Economic Commission for Europe**Inland Transport Committee****World Forum for Harmonization of Vehicle Regulations****Working Party on Lighting and Light-Signalling****Seventy-third session**

Other Regulations – Regulation No. 112 (Headlamps emitting an asymmetrical passing-beam)**Proposal for a Supplement to the 01 series of amendments to Regulation No. 112 (Headlamps emitting an asymmetrical passing-beam)****Submitted by the expert from France***

Figure 1. Light distribution

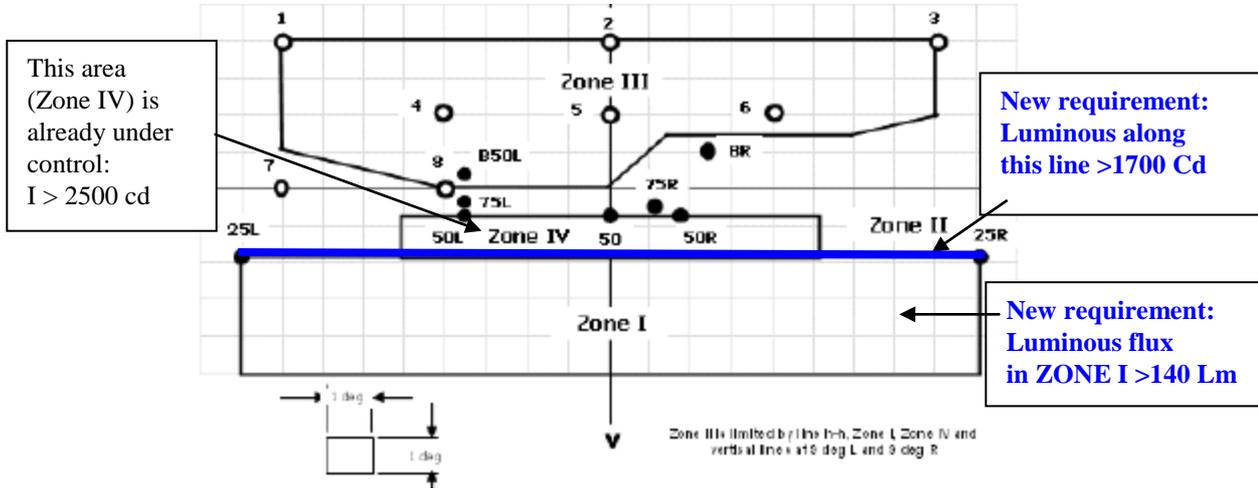
6. To complete the prescription and to ensure that there is enough light on the road, we propose to add a prescription along the line segment (1.72D - 9L to 9R) and a minimum luminous flux inside Zone I, corresponding to a distance comprised between 8.5 and 25.0 m ahead the vehicle (see the figures below).

6.2.9. Along the horizontal line between 25L and 25R (1.72D – 9L to 9R), the luminous intensity shall not be less than 1,700 Cd.

The total luminous flux in “Zone I” shall be not less than 140 Lm.

Figure 2. Prescriptions projected on the Road

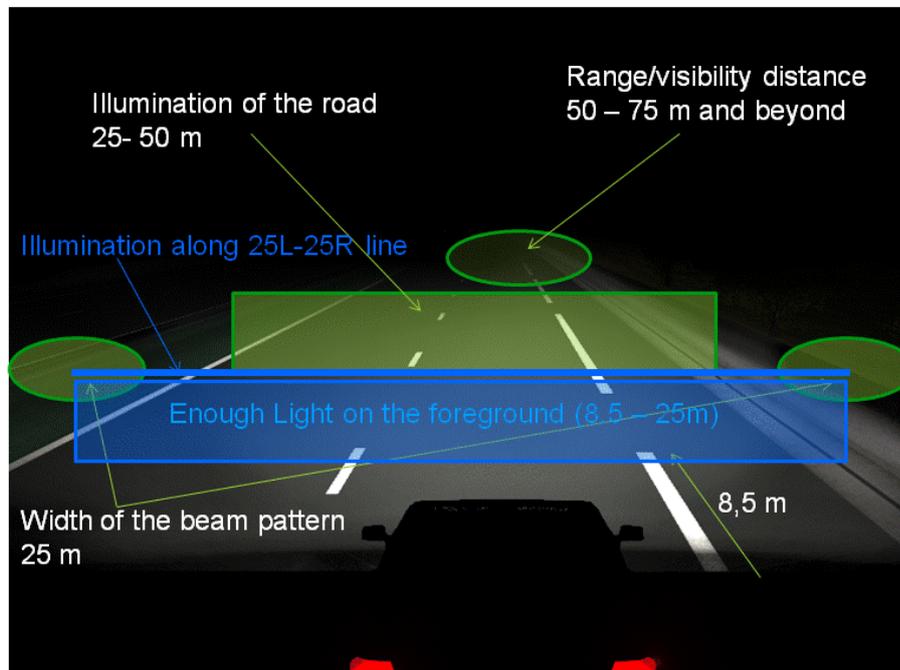
In green : Current prescriptions for visibility distance, 25- 50m area and width of the beam pattern.

In blue : Proposed new prescriptions.
